Proposal for amendments to ECE/TRANS/WP.29/GRE-68-04

(Proposal for amendment to Regulation No. 48)

Delete paragraph 5.27.4., to read:

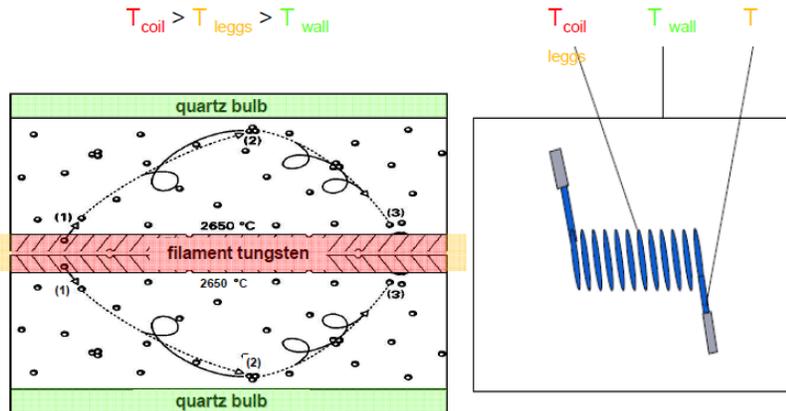
~~5.27.4. In the particular case where devices equipped with a filament light source produce the principal passing beam in conjunction with electronic light source control gear, the effective voltage (root-mean-square, r.m.s.) determined over a sufficient long time to measure the correct value at the terminals of the filament light source when the electrical system of the vehicle is in a constant voltage operating condition according to paragraph 5.27. shall not be less than 6.3 V (6 Volt Systems), 13.2 V (12 Volt Systems) or 28.0 V (24 Volt Systems) minus 3%. Additionally, in the case of filament light sources for which more than one test voltage is specified in Regulation No. 37 this deviation shall not be more than minus 3% from the lowest value of these test voltages that are being applied in the device.~~

~~However, if the electronic light source control gear is part of the device, the necessary measurements may be performed in addition to the procedures for the approval test. The manufacturer shall provide to the Technical Service the value of the vehicle voltage corresponding to the electrical system of the vehicle is in a constant voltage operating condition. The results shall be indicated in the communication document and test report“~~

Theoretical chemical behaviour of halogen light sources

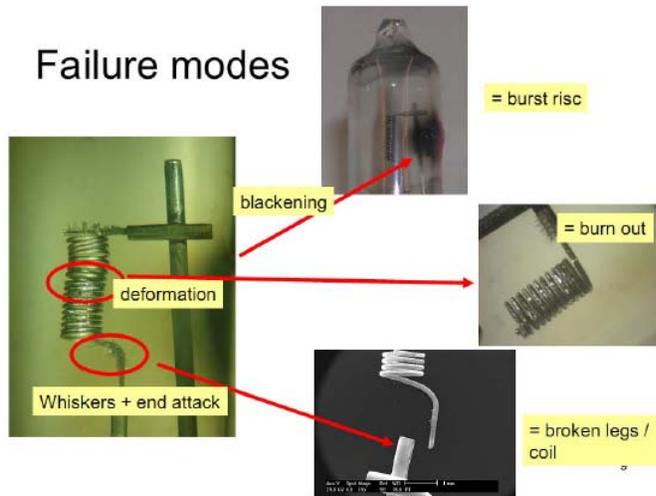
The theoretical behaviour referred to in the above pictures does not justify the complex changes proposed in GRE-68-04. Before adopting the proposal, it would be important to get empirical data on such behaviour, in order to be able to correctly evaluate the probability of the above failure modes. OICA does not accept the proposed changes since such probability seems very low.
